Request for Information – Local Government Official Information and Meetings Act (LGOIMA) 1987

We refer to your official information request dated 26 September 2025 about the cleanfill proposal at 1044 Coast Road, Wainuiomata. You asked a series of questions and requested related documents. Our responses are set out below.

Figure 1 Predicted peak 1% AEP flood depths (with climate change): proposed situation

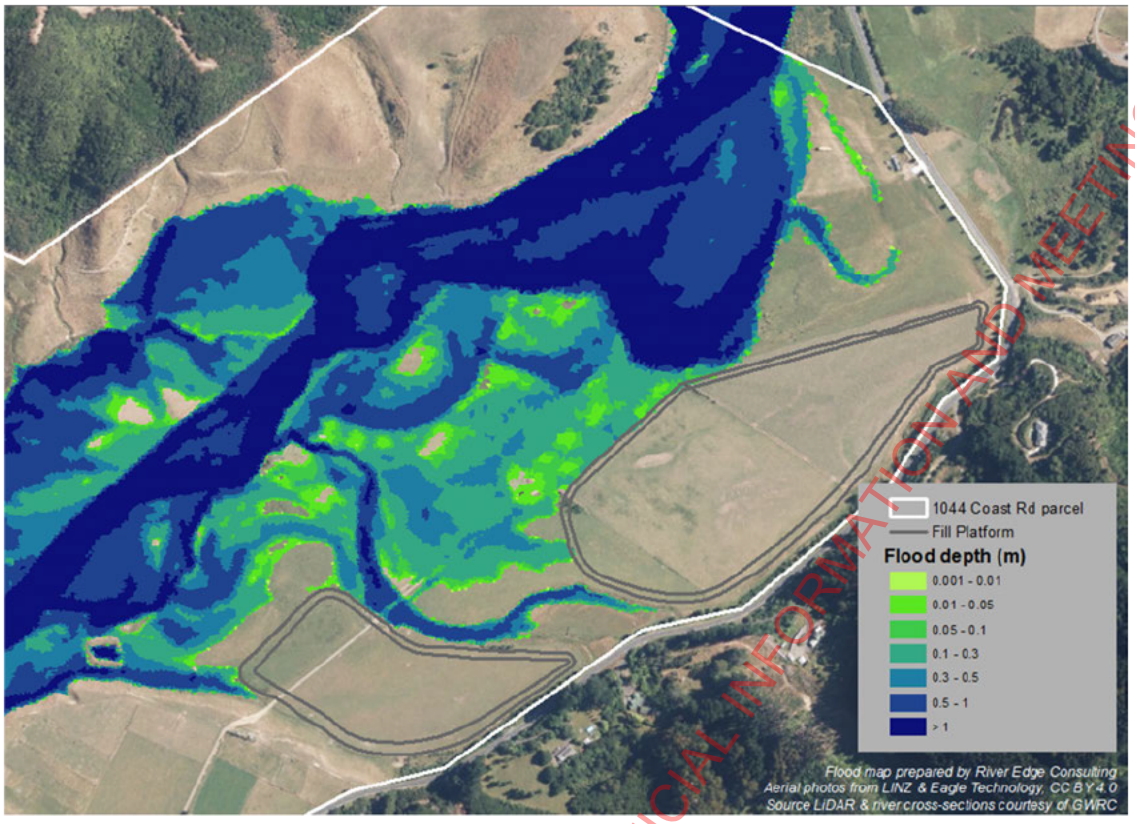
Please clarify whether the 600mm freeboard allowance was included in the scenario simulating the proposed 2m fill. If not, please provide reasons for not including freeboard for this assessment. The flood extent shown on Figure 7 appears to be inconsistent with the results shown on Figures 8 and 9.

Figure 1 below shows the predicted flood depths for the proposed situation, with the fill in place. This figure was not provided in my original letter. Figure 8 of the original letter shows the difference between flood depths in this new Figure 1 and those in Figure 2 of the original letter. As those maps are for the results without the addition of freeboard, they cannot be compared to Figure 7 of the original letter. Likewise, Figure 9 in the original letter shows the difference between the proposed case (Figure 2 below) and the pink of Figure 3 of the original letter, for a sensitivity test with surface resistance increased by 10%.

Figure 12: modelled impact of proposed fill platforms on 1% AEP flood depth. Source: Figure 9, *1044 Coast Rd, Wainuiomata – Flood Modelling* by River Edge Consulting Limited, in Appendix A of the applicant's AEE.

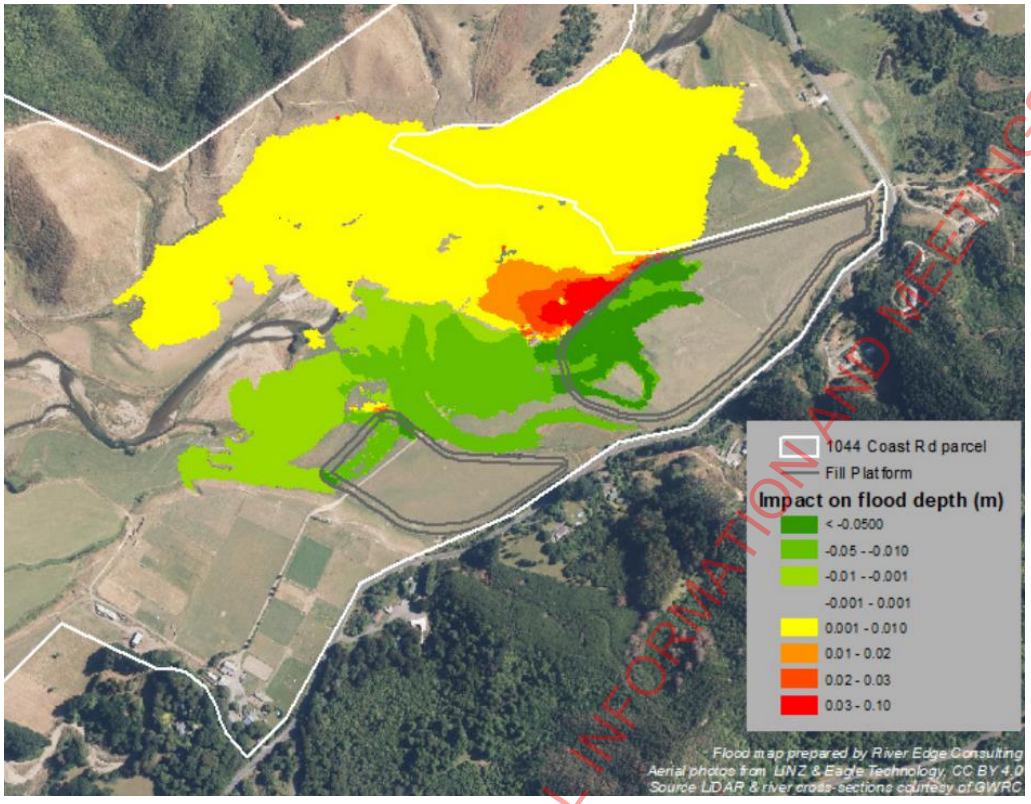
The applicant has modelled the effects that establishing the cleanfill would have on flood levels during the 1% AEP flood event (Figure 12). On the property, while there is generally a reduction in flood levels downstream of the northern cleanfill area, there is an increase in flood levels to the west on the northern cleanfill area of up to 100mm. Outside the property boundary, flood levels are modelled to increase by up to 10mm on the properties to the north (at 904 Coast Road).
